OIL INDIA LIMITED
(A Government of India Enterprise)
P.O. Duliajan – 786602, Assam, India
Website: www.oil-india.com

Corrigendum No. 2 to IFB No. CPI4540P18

Hiring of Services for Engineering, Procurement, Construction Management Consultancy (EPCM) for creation of Surface Production Facilities (GGS and OCS) at Nadua & East Khagorijan, Dibrugarh, Assam

SUB: PROPOSED LAND MAP FOR PRODUCTION SET-UP
WITH APPROACH ROAD AT NADUA

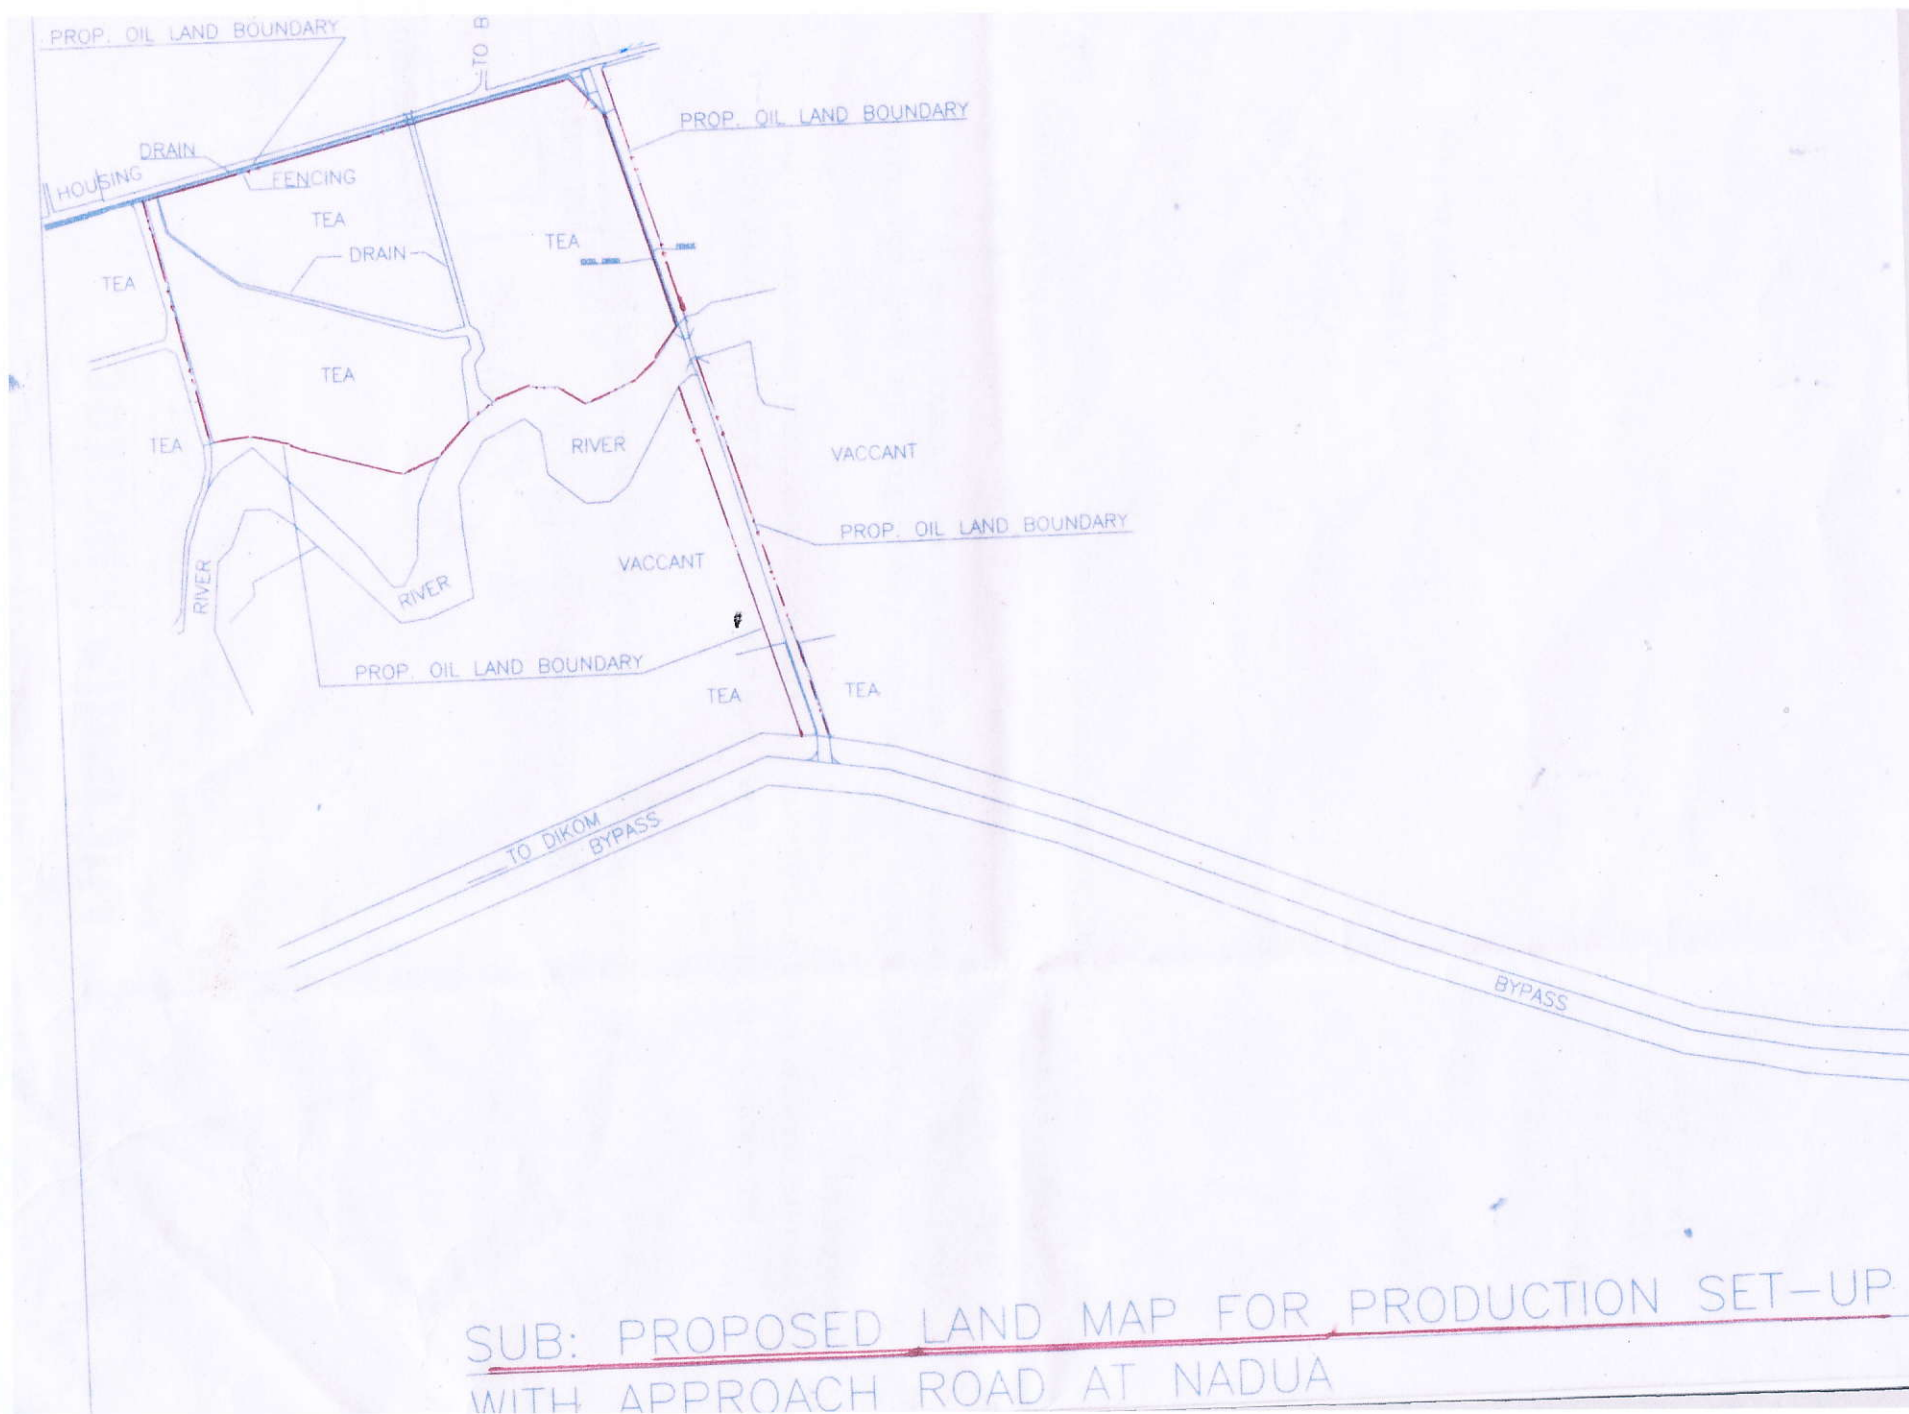
Page no.105 of 214	Part 3 Section – II, Clause: no 15.0 (D) - Land map is attached	Land map of Nadua is enclosed as Annexure – L.
Page no.73 of 214	Part 3 Section – II, Clause: 4.3-E(Note) – (ii)	Apart from the requirement mentioned in the clause, Certified professional within bidder's organization can also conduct/perform the studies, but prior to their engagement the credentials of the same will have to be approved by OIL.
Page no.93 of 214	Part 3 Section – II, Clause no.8.0: Project Schedule: The brief break up (tentative is as below), but the actual schedule has to be submitted by EPCM as per project scope after award of LOA	The brief breakup of the project duration (26 months from the date of LOA to EPCM) is only indicative and contains overlapping period and the exact and accurate breakup has to be planned by EPCM keeping the total project duration as 26 Months only from the date of issue of LOA to EPMC and get the same approved by OIL during project Kick Off Meeting.
